**MAY RIVER ROAD IMPROVEMENTS
PHASE 2**

**T&H PROJECT No.
J-23039.0000**

ADDENDUM NO. 1

JUNE 28, 2016

C3.5

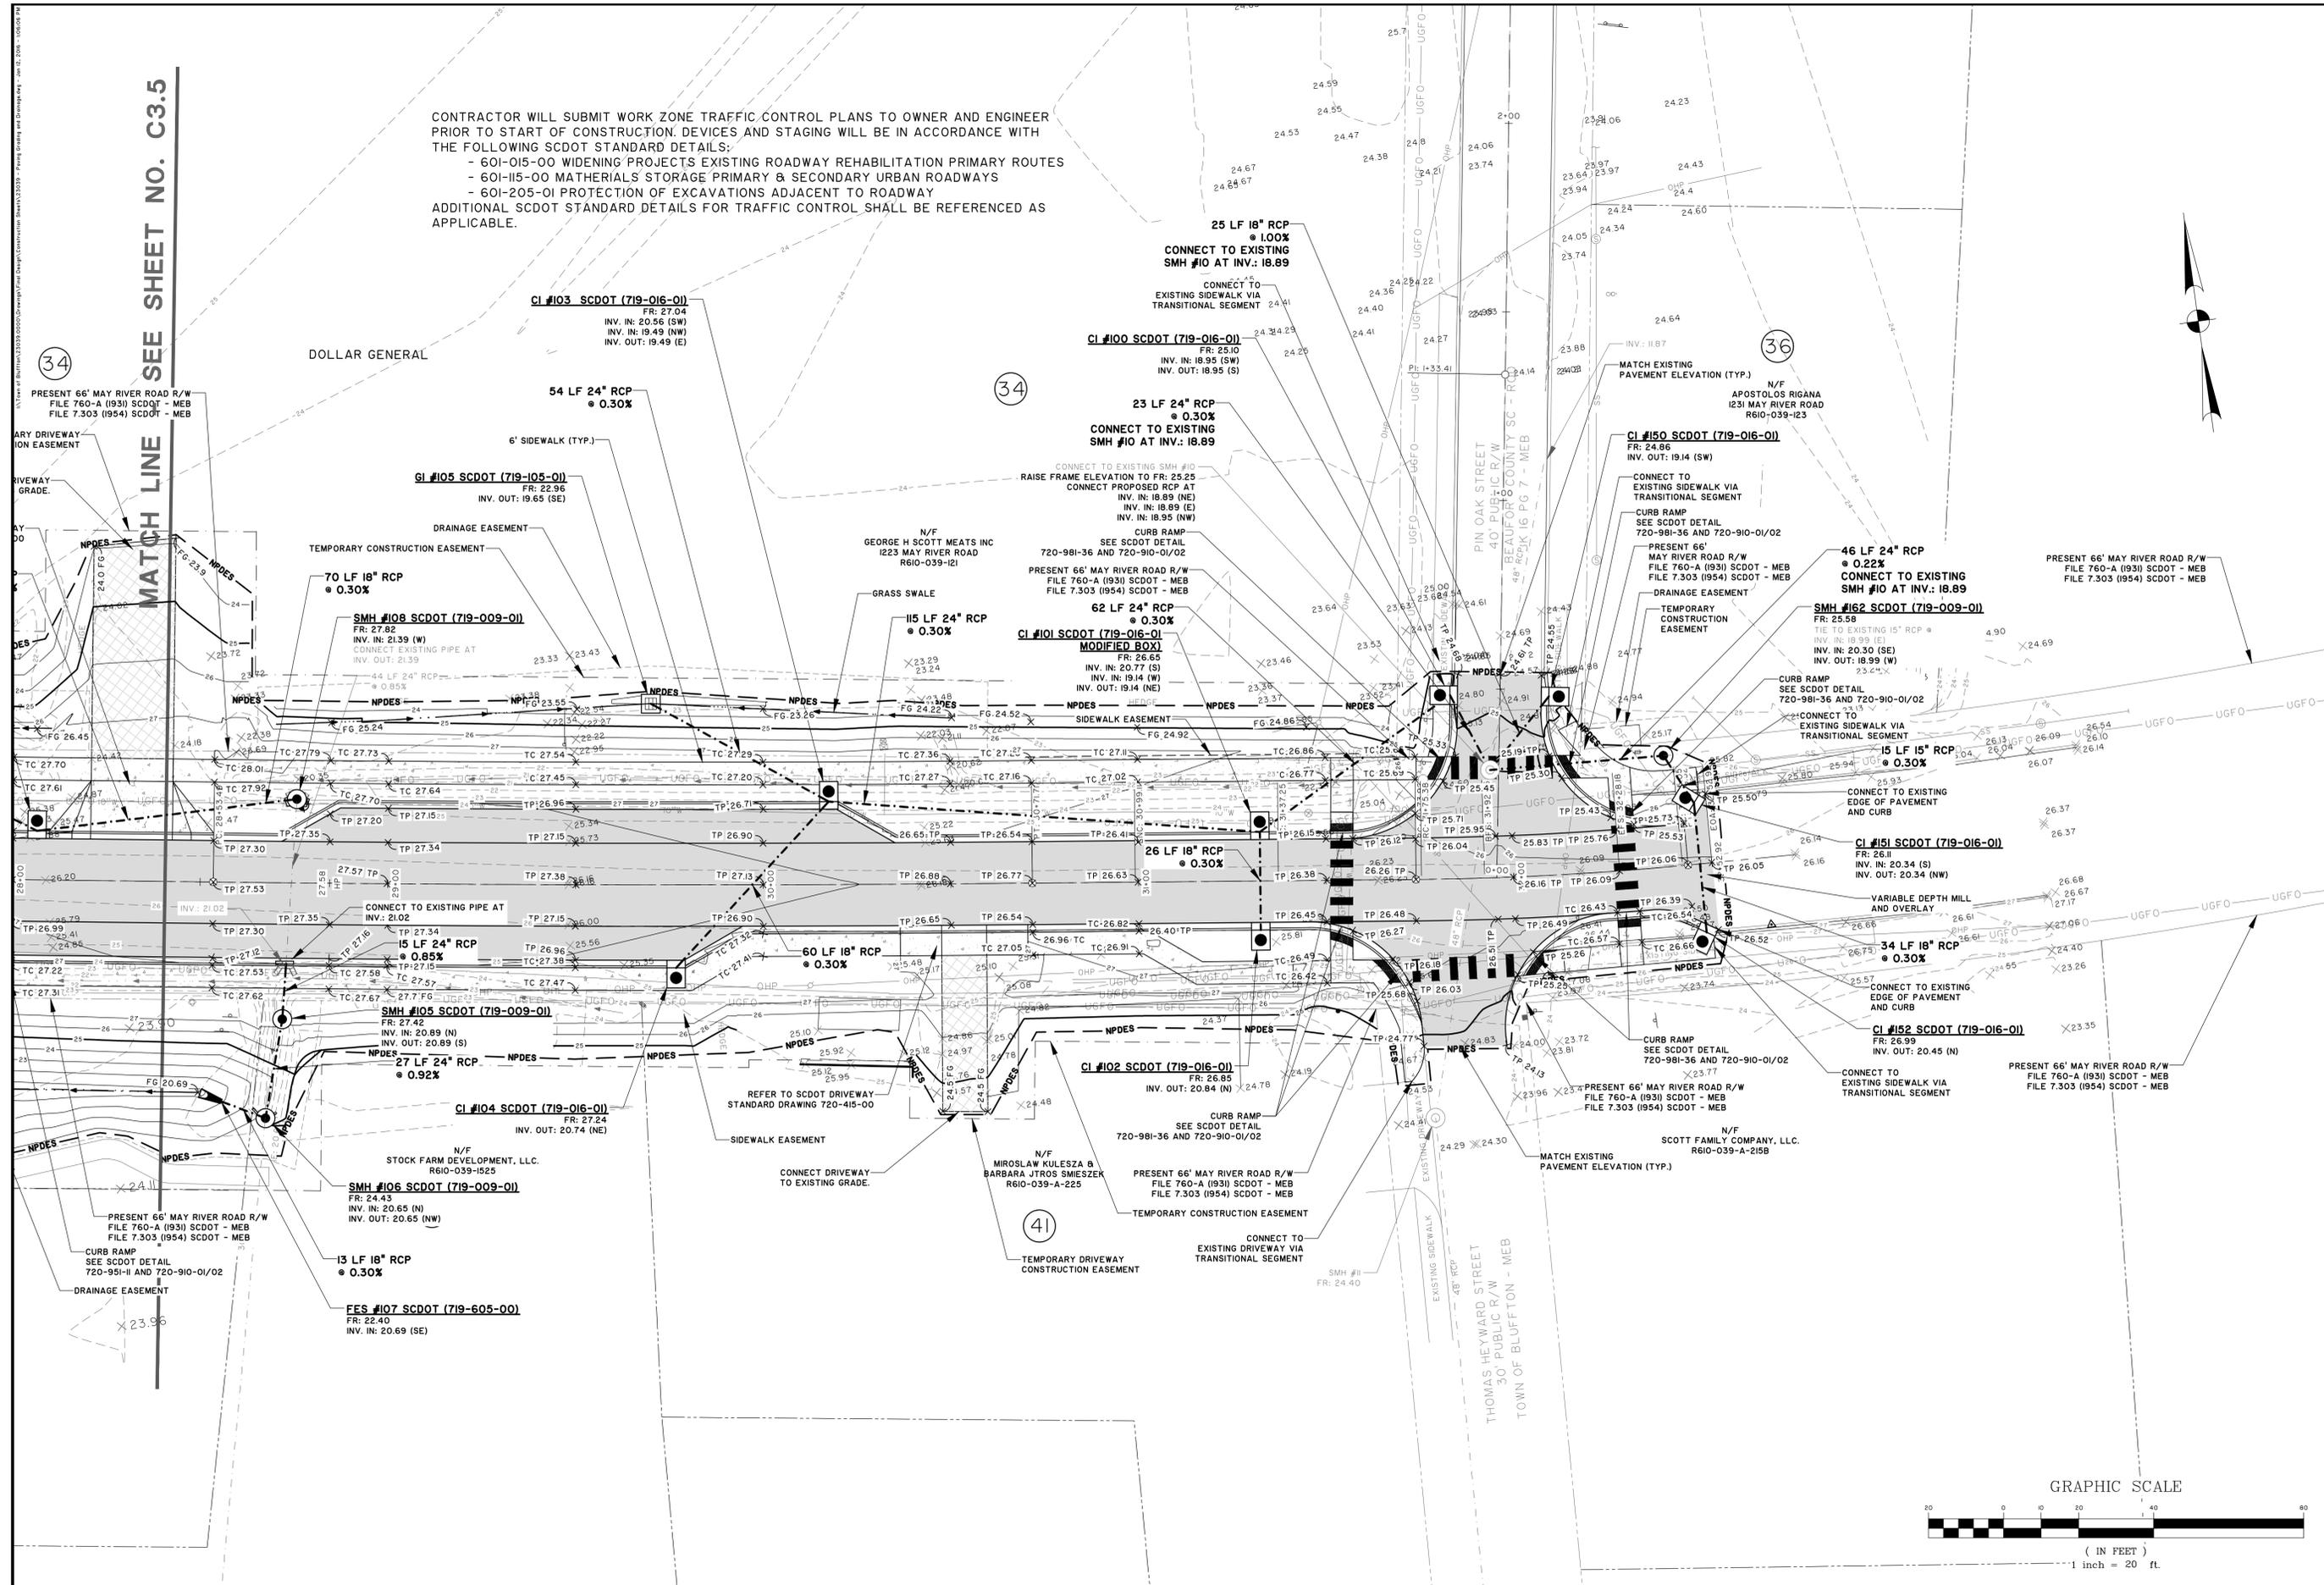
Paving Grading and Drainage Plan Sheets C3.5-C3.6.

- Notes for Sidewalk Connection and Sidewalk Easement near STA 28+00 (south side of road) moved to correct location near STA 27+00.
